STAFF REPORT: APRIL 9, 2025 MEETING

APPLICATION NUMBER: HDC2025-00107

ADDRESS: 14615 E. JEFFERSON & 1000 PHILIP

SCOPE: DEMOLISH AND REBUILD EXTERIOR WALLS, ERECT ADDITIONS & TRASH ENCLOSURE

Existing site plan.

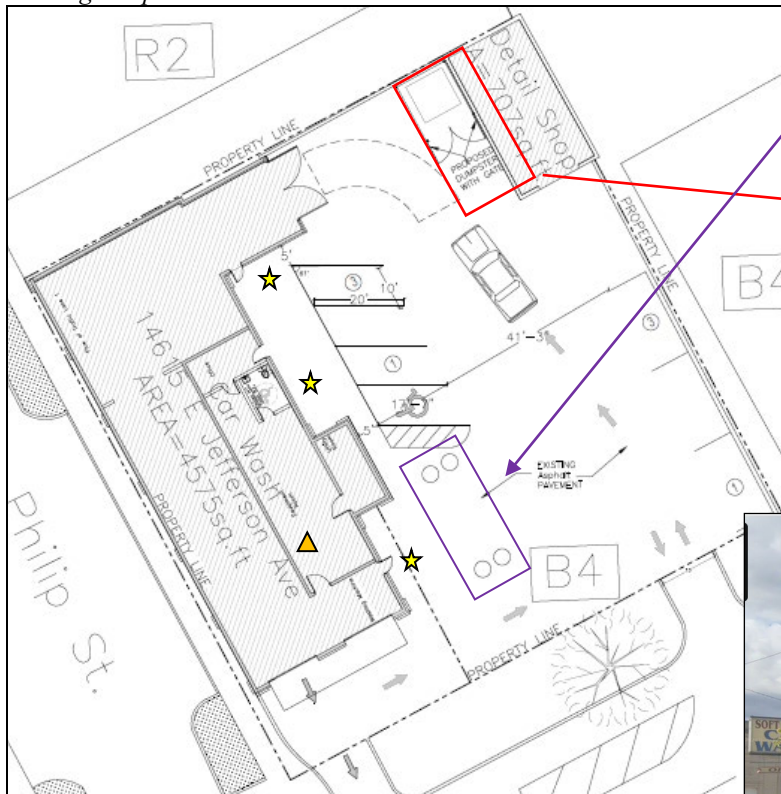
Adjacent the existing secondary building will be a new trash container. (While it is shown on this existing site plan, there is not a container at this location now.)

The majority of outer rooms along the east wall will be demolished, creating additional open space within the parking lot for use as parking spaces.

- Yellow stars on the existing and proposed site plans denote the areas of the building that will be demolished.
- The number of exterior doors at this area will be reduced from five to three.

Rooms will be erected within the existing building (▲).

The existing freestanding signs - one tall two-sided lighted "Soft Cloth Car Wash" sign near the corner of E. Jefferson and Philip, and one smaller two-sided wood board "Everyday Wash \$6" sign - are not shown on the existing nor the proposed site plans. The flagpole is also not noted on both site plans. The exterior equipment/vacuums are noted and will be reduced from three locations to two.

Façade: Existing (left) vs. proposed (right). Applicant drawings.

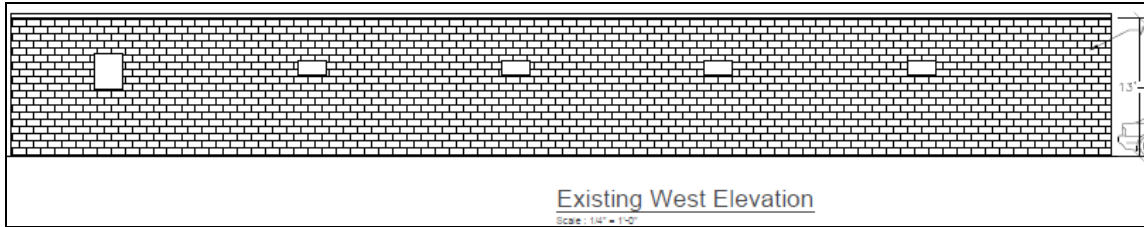
- The existing building has brick cladding on the front wall of the building, but the remaining walls are exposed concrete block and vinyl siding. Staff commends the proposed design that specifies a unified cladding material and design for all four walls; however, the vinyl siding proposed for the exterior cladding is not an appropriate material within a historic district with an early 20th century period of significance.

- Vinyl siding has visible vertical joints and does not match the surface texture, finish, edge details, and at times width and reveal, of a historic building material, such as wood siding or brick.

- Vinyl siding is a panelized product with molded edges that also imparts a sheen, all of which is in contrast with crisp edges of wood siding with a painted matte finish.

- The proposed color scheme is white vinyl lap siding and “deep ocean” blue vinyl vertical panels. This is a highly contrasting color palette that is not consistent with the general characteristics and atmosphere of the district.

- A wall cladding material that is compatible with the dominant cladding materials in the district, brick and cast stone, will be selected, as will a neutral color (or colors) that fall within the range of natural brick colors. Material samples will be submitted for staff review.

West wall (facing Philip): Existing (above) vs. proposed (below). Applicant drawings.

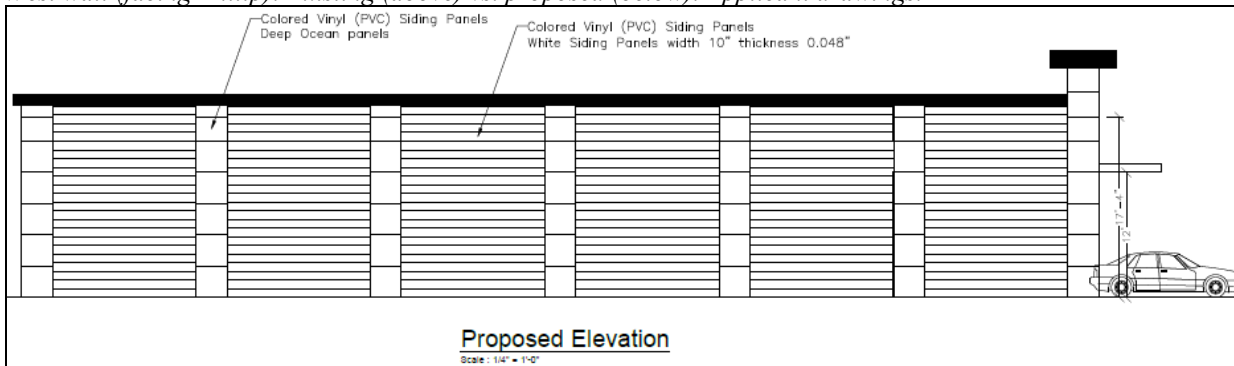
- The plans identify the height of the existing structure is 13’-3”. The proposed wall height (including parapet) for the east and west walls, and a portion of the north wall for the altered structure is 19’-6”; the front wall is to be 21’ (plus the height of the overhanging decorative trim). The taller, rectilinear massing and lack of applied ornament is a compatible design within the district. Additionally, as the historic structures on either side of 1000 Philip/14615 E. Jefferson are three stories tall (and 14635 E. Jefferson is over three stories tall when taking into account the height and massing of the steeply pitched roof), the additional height for the car wash structure will create a more proportional relationship to the adjacent buildings, increasing the compatibility of this noncontributing property.

Above: This street view captures the car wash with the adjacent historic/contributing properties. Google maps photo.

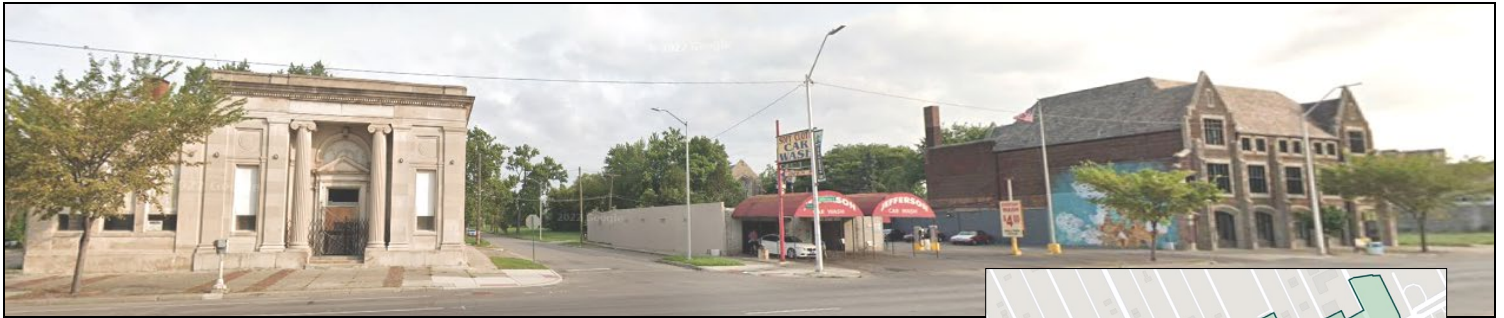
- As seen in the streetscape photo above, the half-round awnings are the dominant feature of the existing car wash. The proposed flat, 12’-high metal clad awning that will extend over both automobile exits will be a minimally visual feature at the front of the car wash.
